Location	62 Beresford Rd Bellevue Hill NSW 2023 Australia Lot A 332414
Proposed Work	Residential Alterations and Additions
Town Planner	Michael Neustein e: City Planning Works Level 2 / 282 Oxford Street Bondi Junction NSW 2022 02 9387 1333
Geotechnical	Scott Easton e: scott.easton@douglaspartners.com.au Douglas Partners 96 Hermitage Road West Ryde NSW 2114 02 9809 0666
QS	Sabrina Tapson e: MBM Level 5 / 1 Chifley Square Sydney NSW 2000 02 9270 1000
Structural	Richard Green e: Richard Green Consulting
Hydraulic	Paul Smith e: psmith@vosgroup.com.au VOS Group Suite 802, Level 8, 99 Mount Street North Sydney NSW 2060 02 8458 2700
Surveyor	Andrew Mason e: andrew@mason.net.au Frank M Mason & Co 2 Winslow Street, Milsons Point, NSW 2061 02 9929 6233
Landscape	William Dangar Dangar Barin Smith PO Box 239 Botany NSW, 1455 02 9316 9044

Project	Drawing title	Title Sheet
331 62 Beresford Rd Bellevue Hill, NSW	Scale Date Drawn by	NTS @ A1 26/11/21 EK
Copyright Collins and Turner 2023	Drawing Number+ Revision	331_DA_000 E

1 North-East Elevation Proposed
1:100

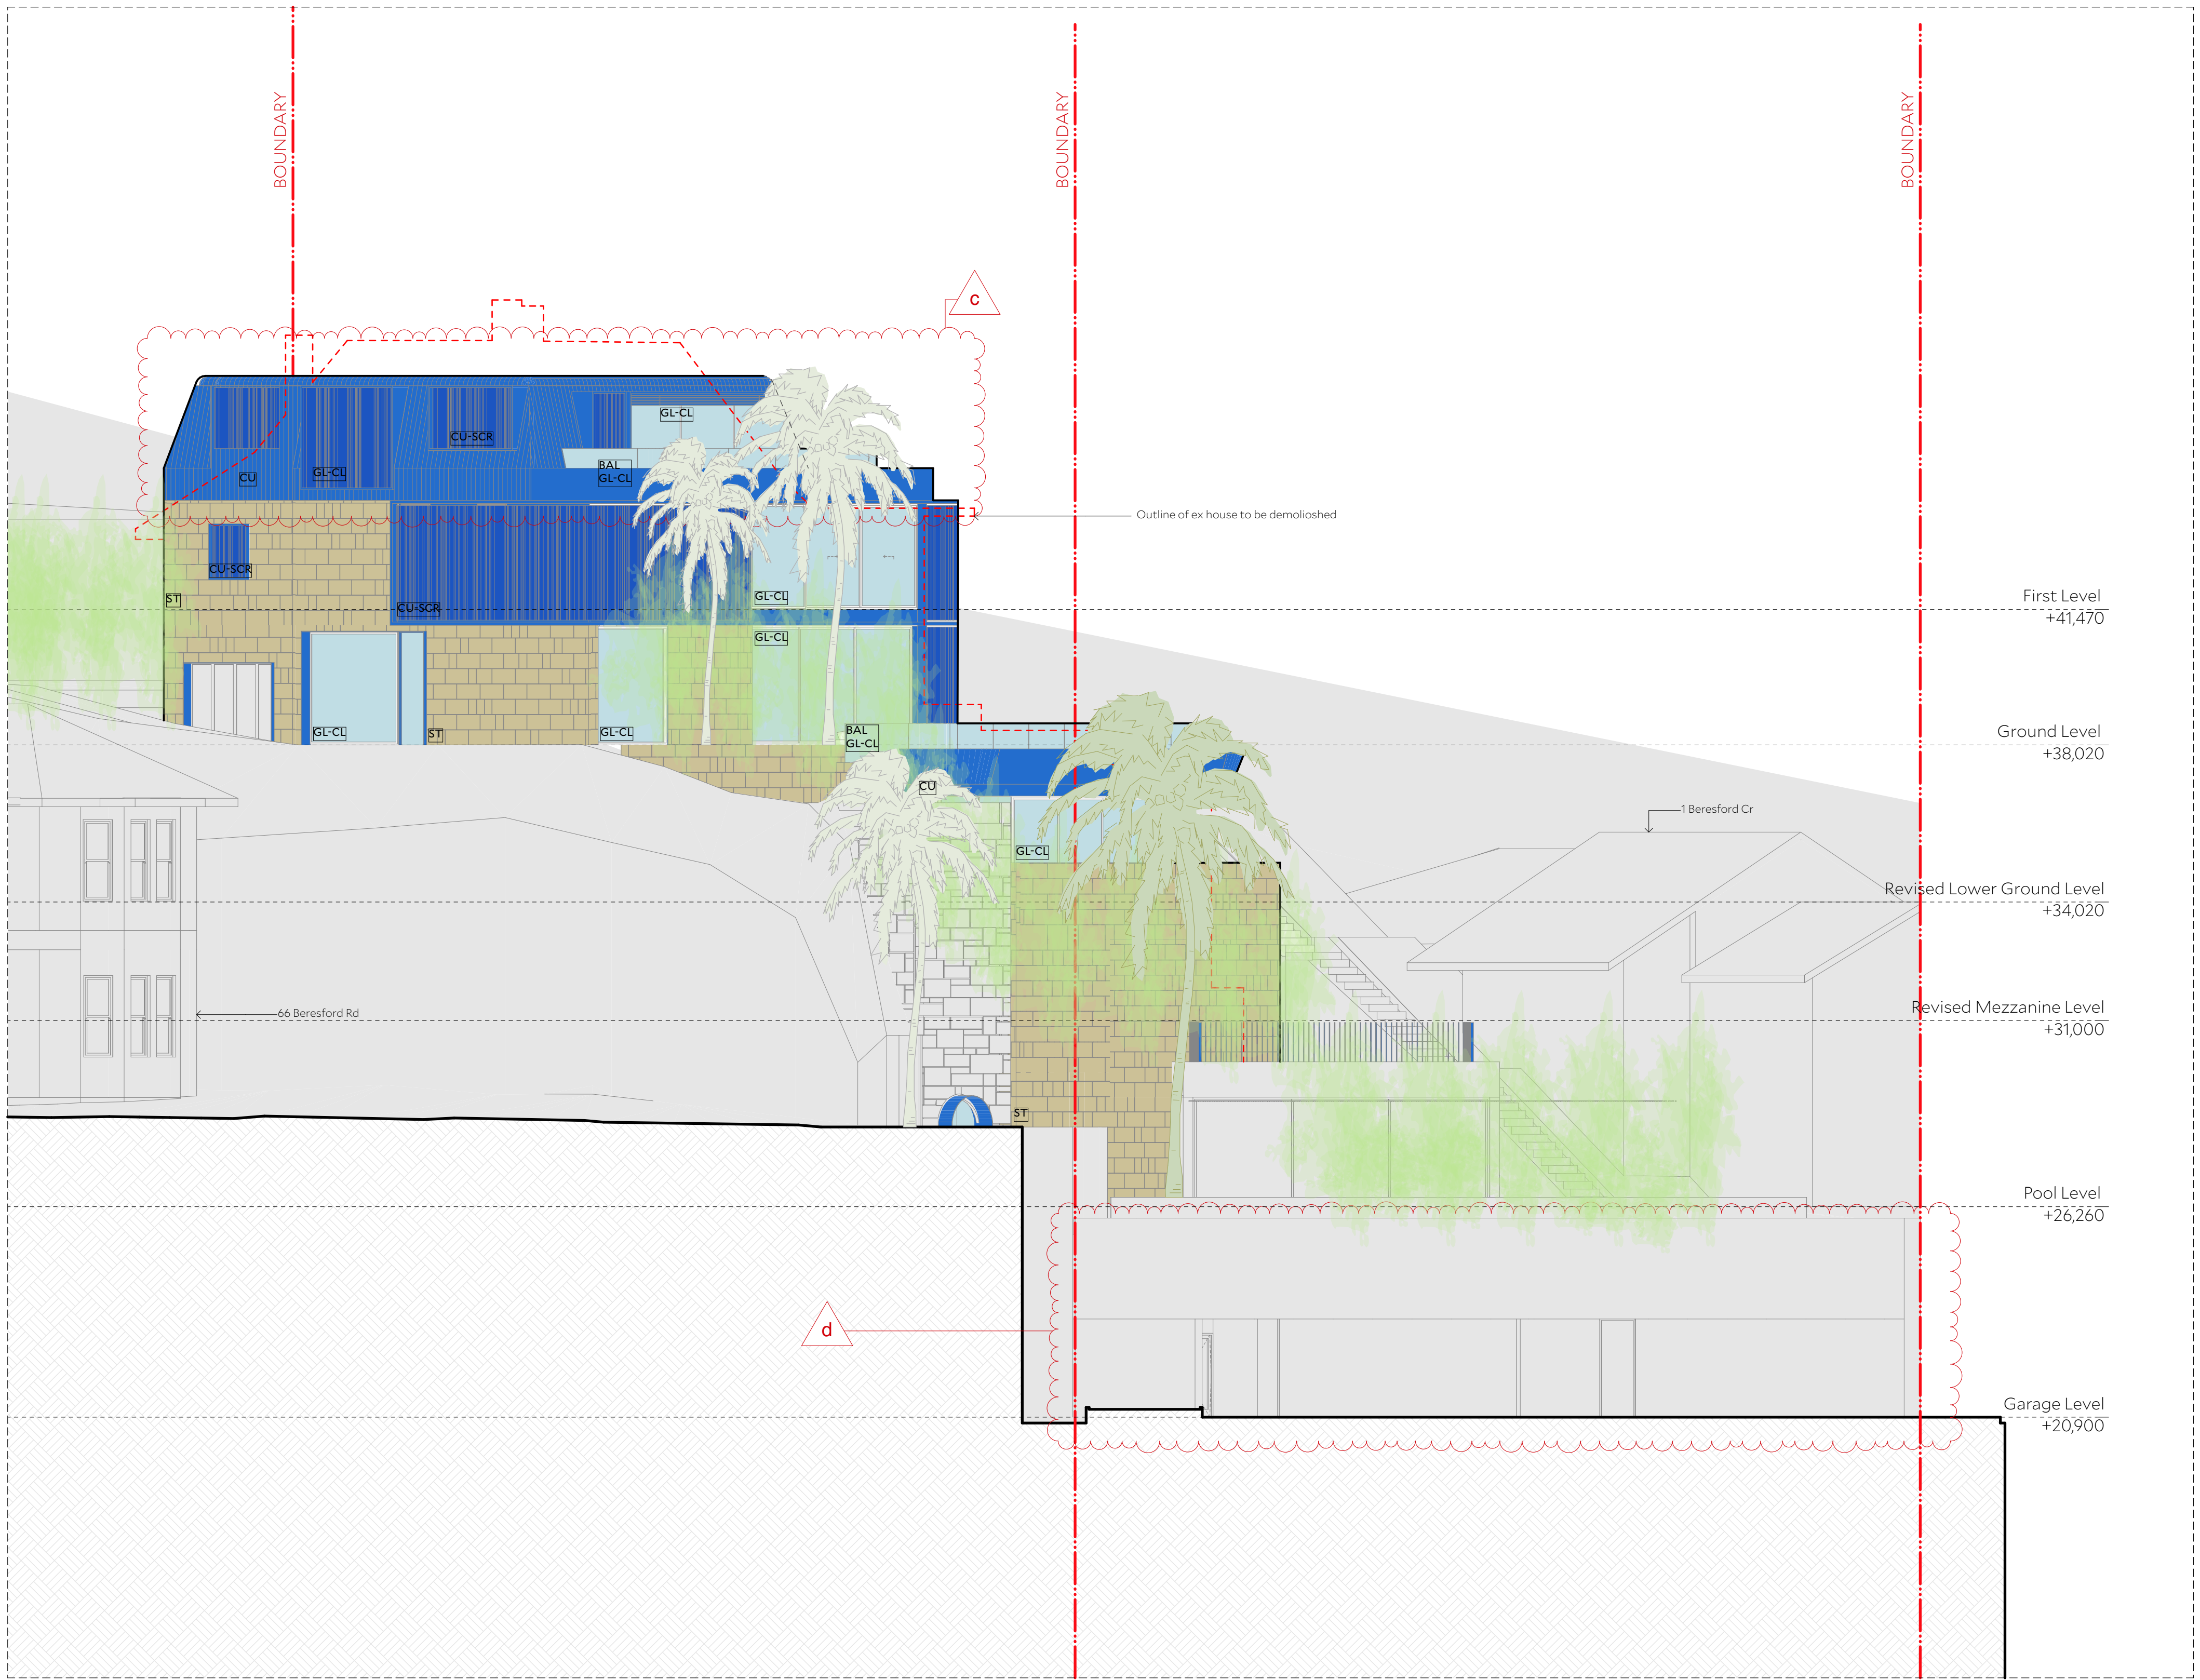
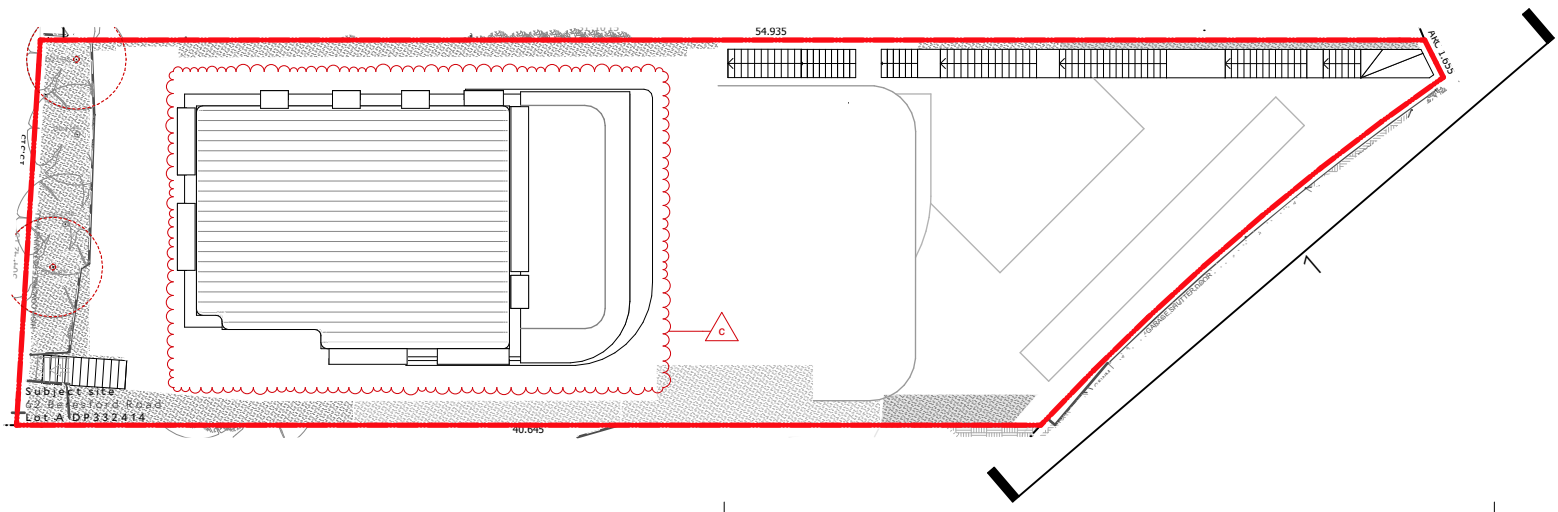
- Change register**
- c. - Southern attic wall moved south 500mm
 - WC relocated
 - Northern attic wall moved south 1000mm
 - Upstand added to terrace perimeter to height of 500mm above FFL
 - Planter box added to full perimeter of terrace.
 - Perimeter walls of attic space inclined by 15°
 - d. Landscaping removed

1 Long Section 1
1:100

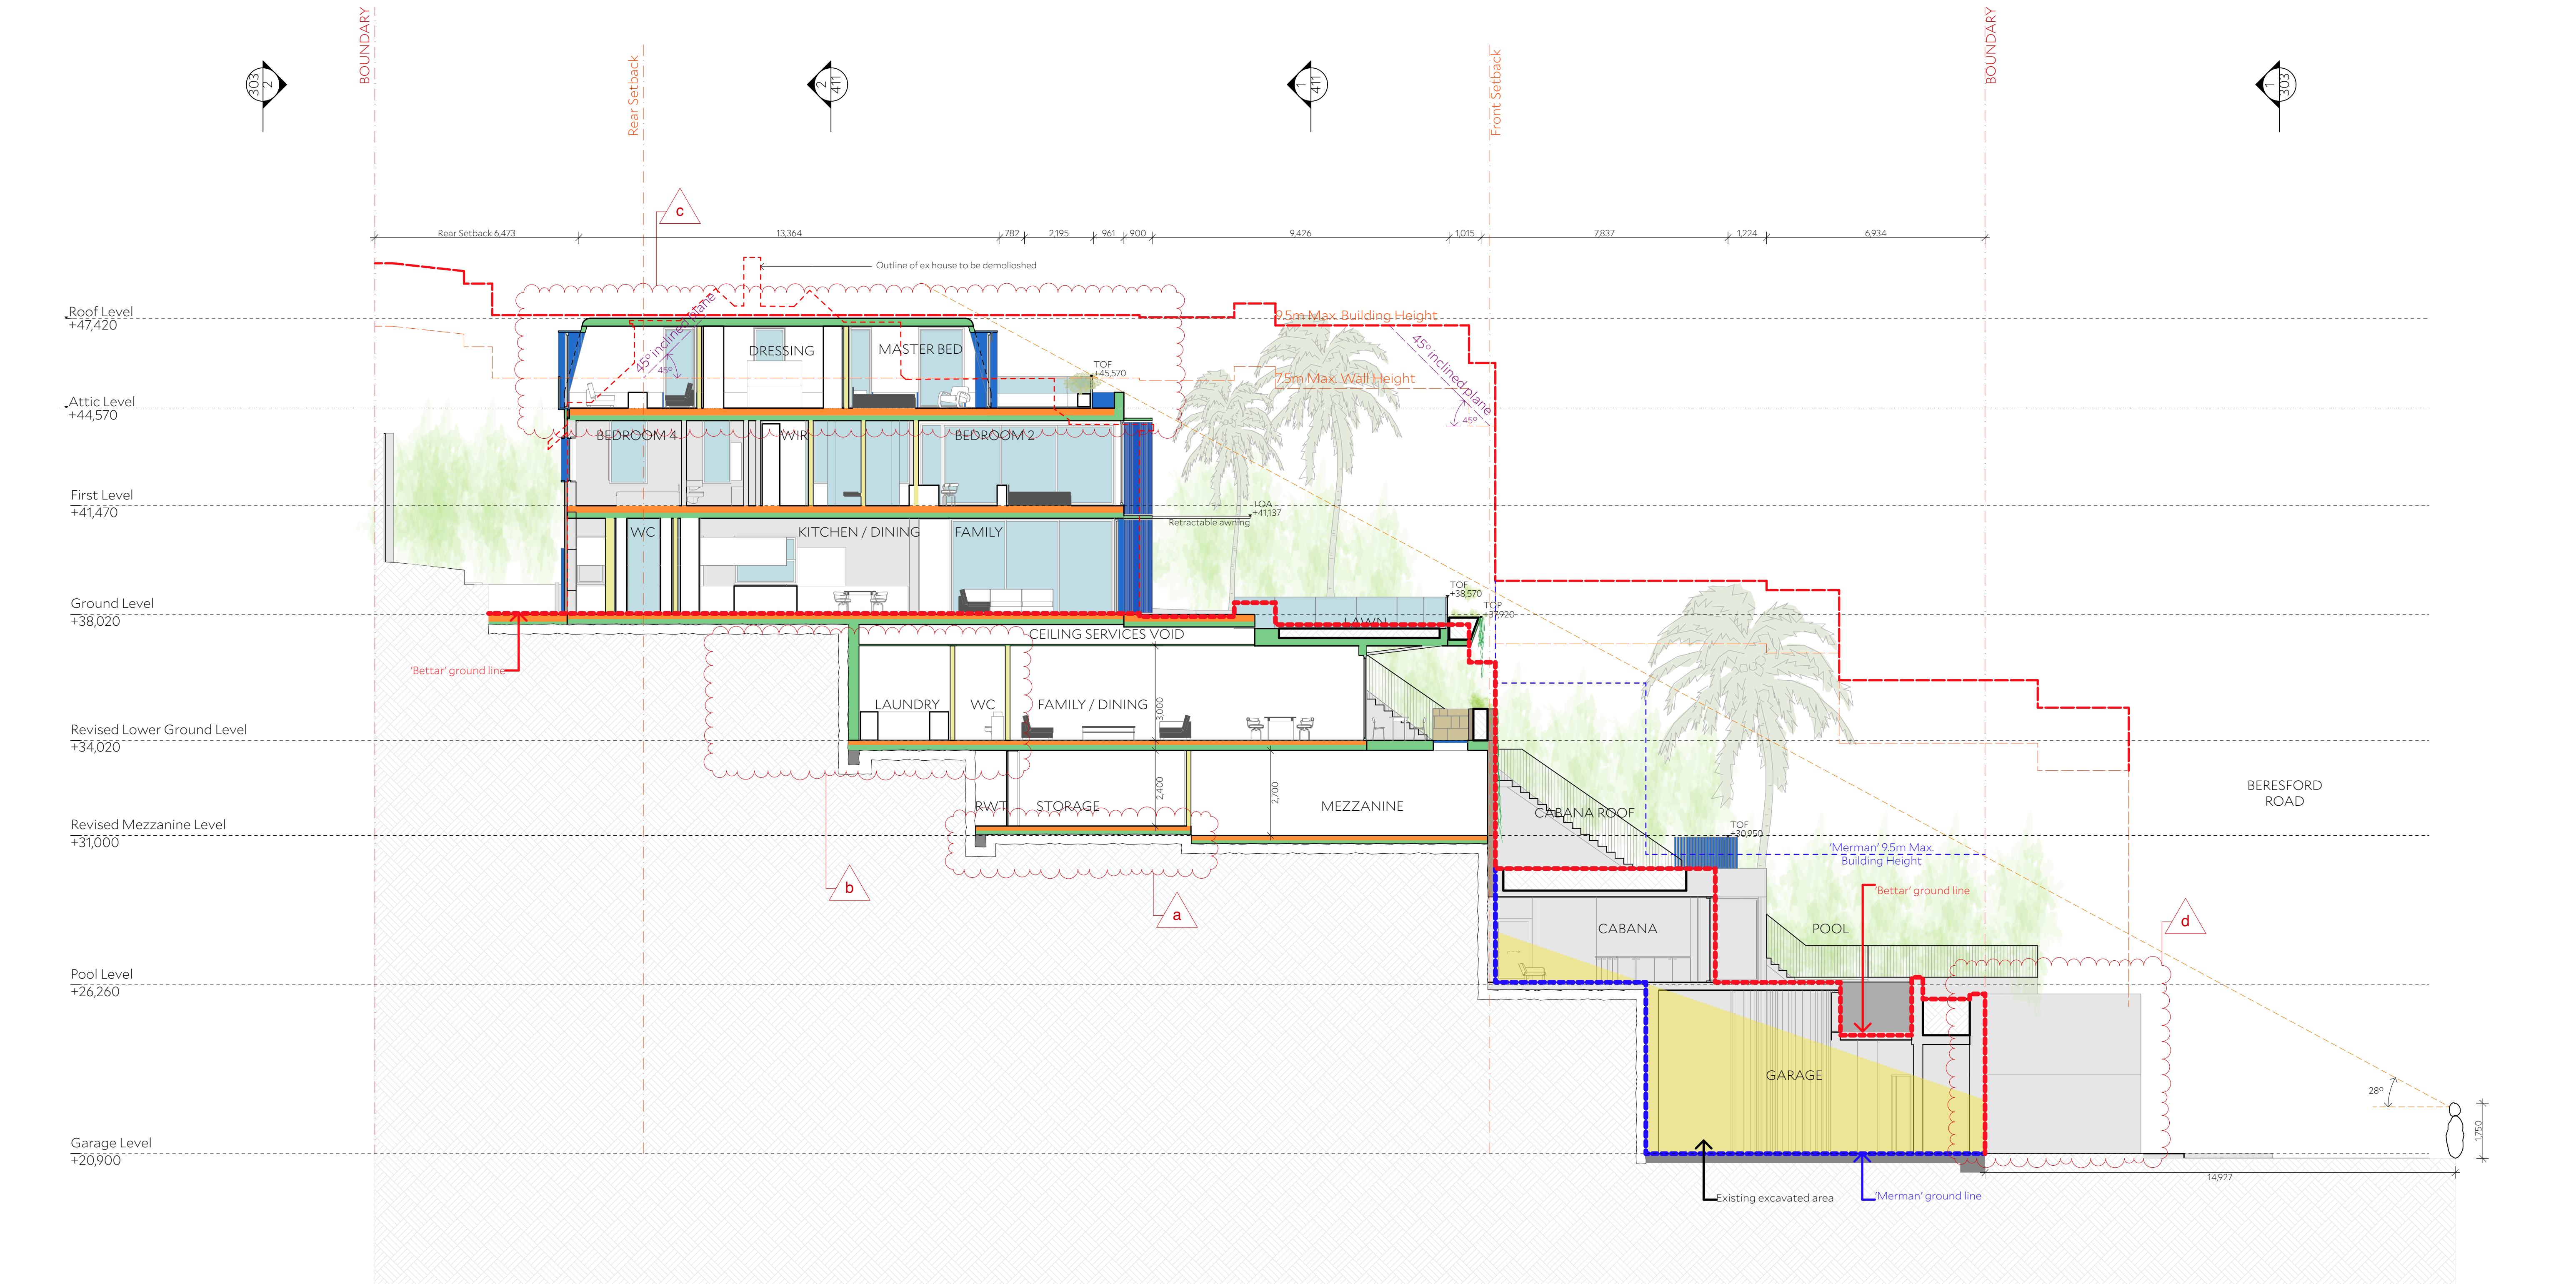
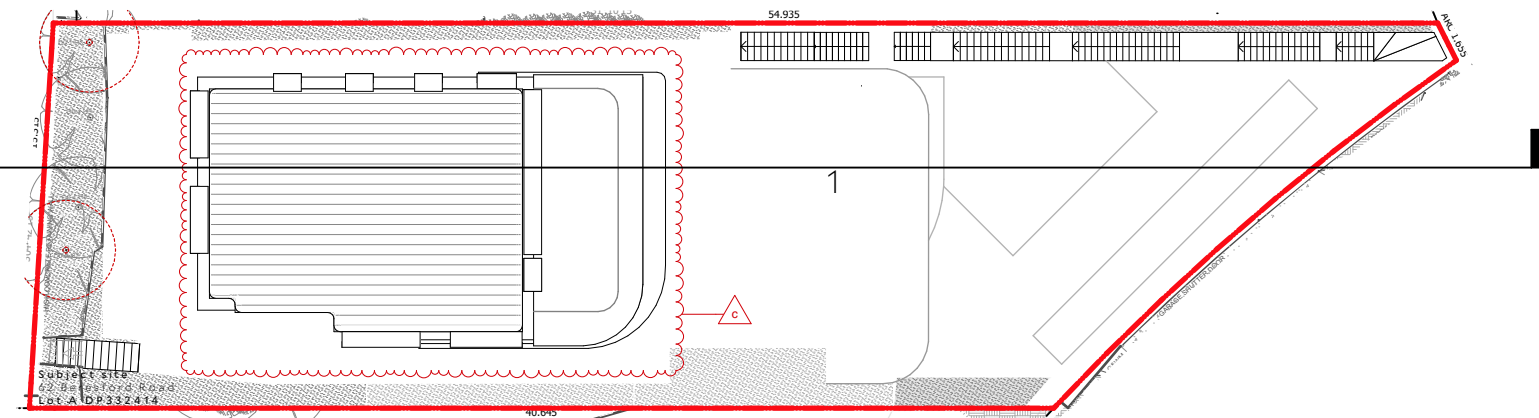
- Change register**
- a. Mezzanine FFL raised by 300mm, floor to ceiling height now 2400mm
 - b. Laundry and Guest WC moved north, resulting in reduction in excavation
 - c. - Southern attic wall moved south 500mm
- WC relocated
- Northern attic wall moved south 1000mm
- Upstand added to terrace perimeter to height of 500mm above FFL
- Planter box added to full perimeter of terrace.
- Perimeter walls of attic space inclined by 15°
 - d. Landscaping removed
